Subaru Announcement

UPDATE Safety Recall: WRL-22 PTC Heater Ground Bolt

Updated, Service Procedure

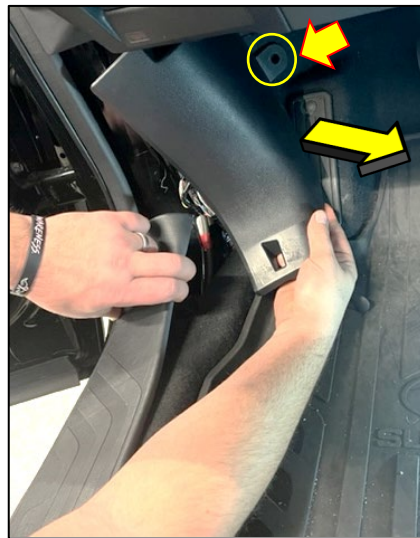
Higher than expected breakage of the Left rear side sill cover (aka. driver's side door-sill trim) has been occurring during this service procedure. The latest update to the WRL-22 Technical Service Bulletin addresses this, and provides recommendations for accessing the PTC heater, without the need to fully remove the Left rear side sill cover. It is recommended that retailers implement this new procedure as soon as possible. Edits to the TSB are shown below.

STEP 3: Remove the mounting nut securing the left front side sill cover. CAREFULLY detach the front section of the left rear side sill cover. While holding the front section, use your other hand to detach and remove the left front side sill cover.

CAUTION: ALWAYS remove the cover when it is or has reached room temperature. Any attempts of removal in cold ambient temperatures may result in unwanted breakage. DO NOT use excessive force when pulling the covers. This may cause damage to the covers.
